CITY PLANNING COMMISSION

APPLICATION: R-Review to allow a car wash in the C-2-R zone.

LOCATION: 2813 Florin Road, Sacramento, California.

PROPOSAL: The applicant is requesting the necessary entitlements to renovate and expand an existing car wash.

PROPOSED FLOOR PLAN

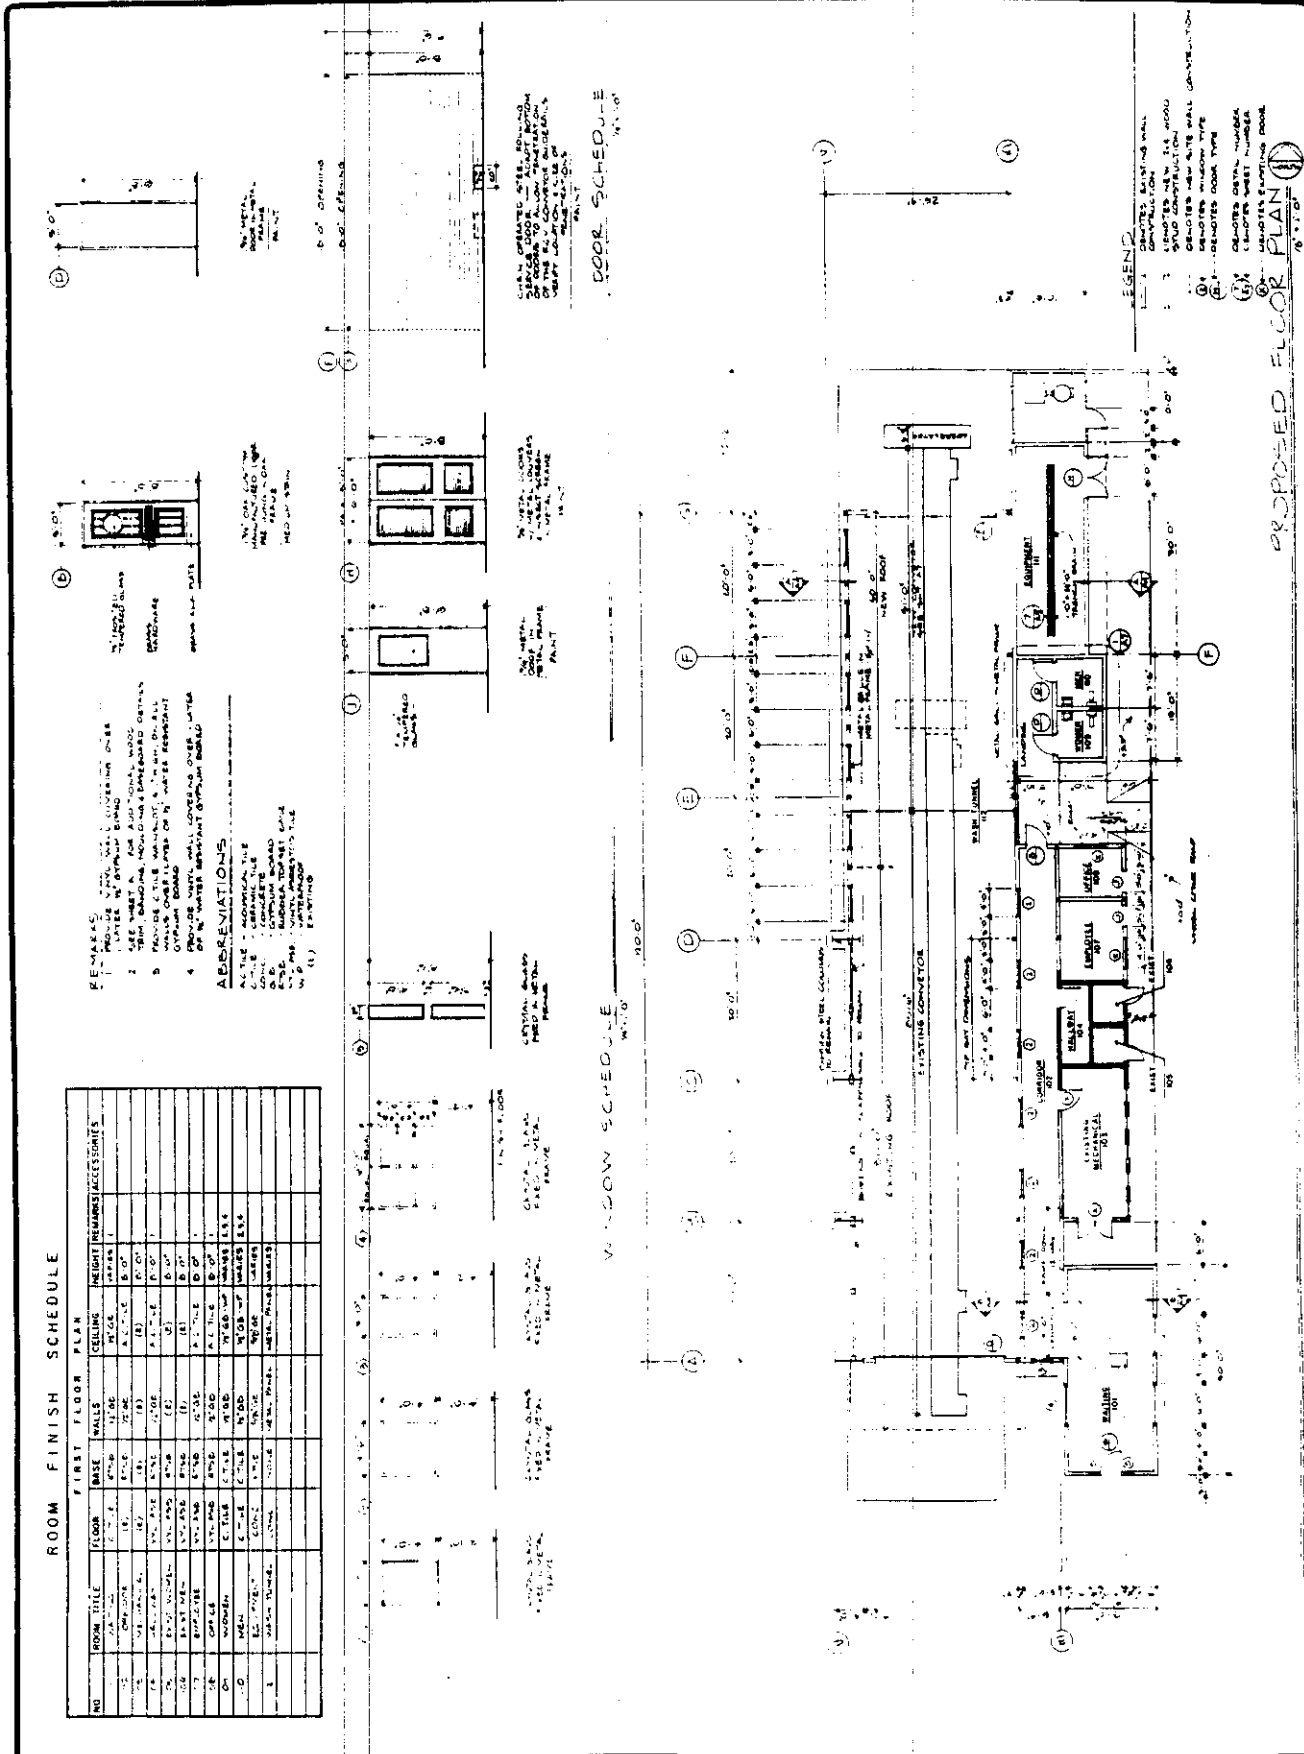
The proposed trash enclosure will be located approximately fifty feet from the front property line and within the sixty foot front setback. Staff recommends this trash container be relocated ten feet to the north so that it is outside the sixty foot front setback.

The applicant proposes a trash enclosure constructed of wood. However, staff recommends the trash enclosure be constructed of solid masonry block because it is a more durable building material than wood. Staff also recommends the trash enclosure be constructed in conformance with the following guidelines:

1. The proposed trash enclosure shall comply with the following:
 - a. The walls of the trash enclosure structure shall be constructed of solid masonry material with decorative exterior surface finish compatible to the main structure. Split face concrete block finish is recommended. Brick or tile veneer exterior finish should be avoided.

- b. The trash enclosure structure shall have decorative heavy gauge metal gates and be designed with can bolts on the doors to secure the gates when in the open position.

- c. The trash enclosure facility shall be designed to allow walk-in-access by employees without having to open the main enclosure gates.
 - d. The walls shall be a minimum six feet in height.

- e. Locate trash container behind the required sixty foot front setback.
2. Reduce west driveway to twenty feet in width and designate one-way exit only with monument signs as required by the City Traffic Engineer.

PROPOSED ELEVATIONS

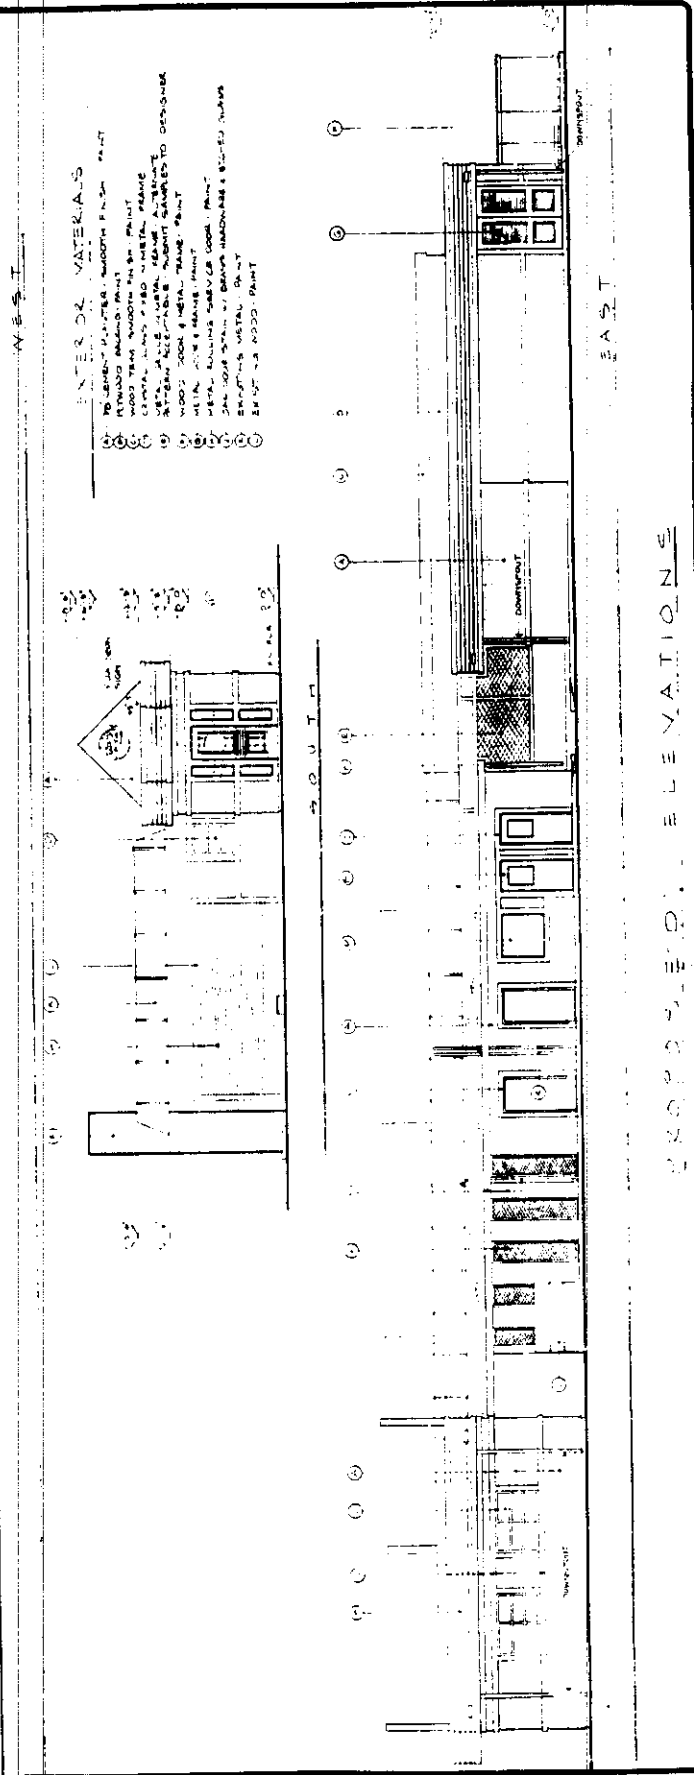
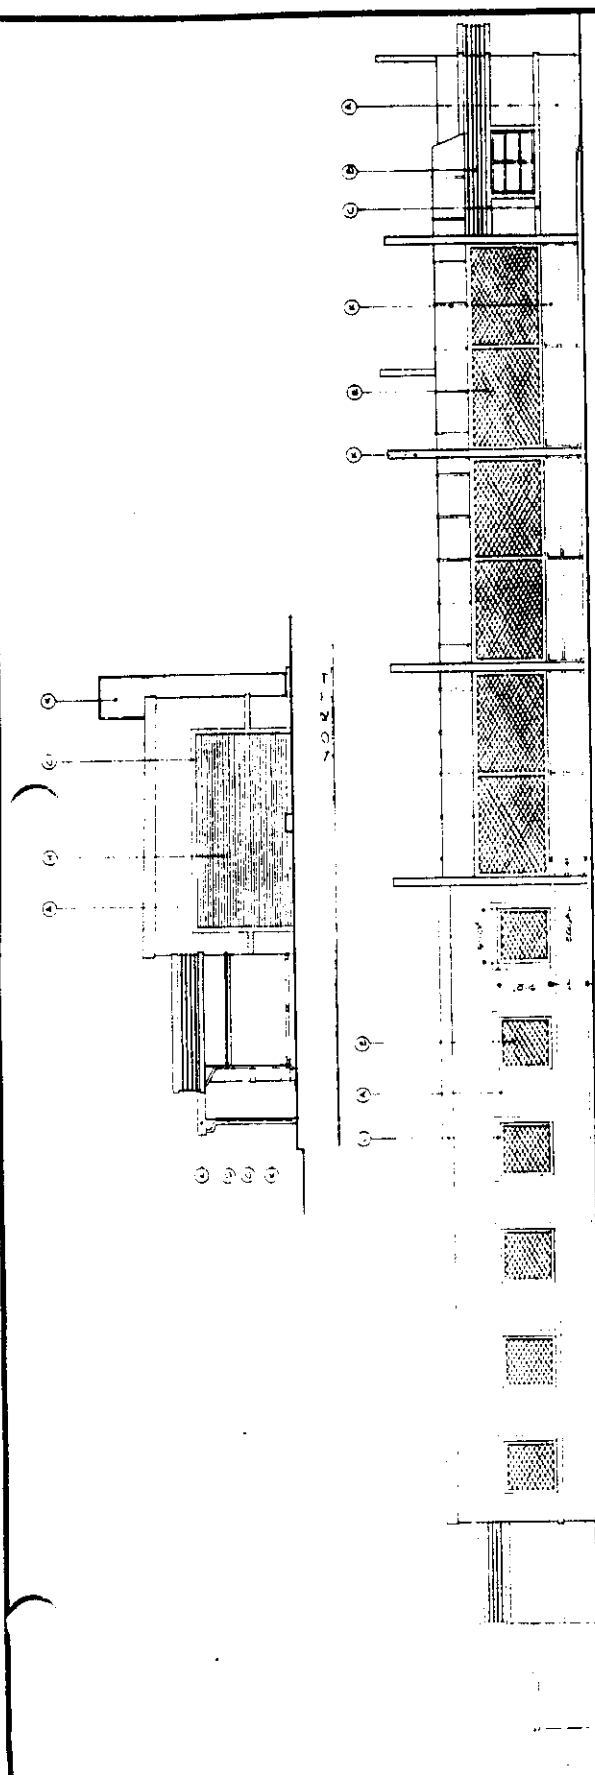
A three foot diameter attached neon sign is also proposed. See south elevation. This proposed neon sign will require a sign permit. Staff has no problem with the neon sign as proposed.
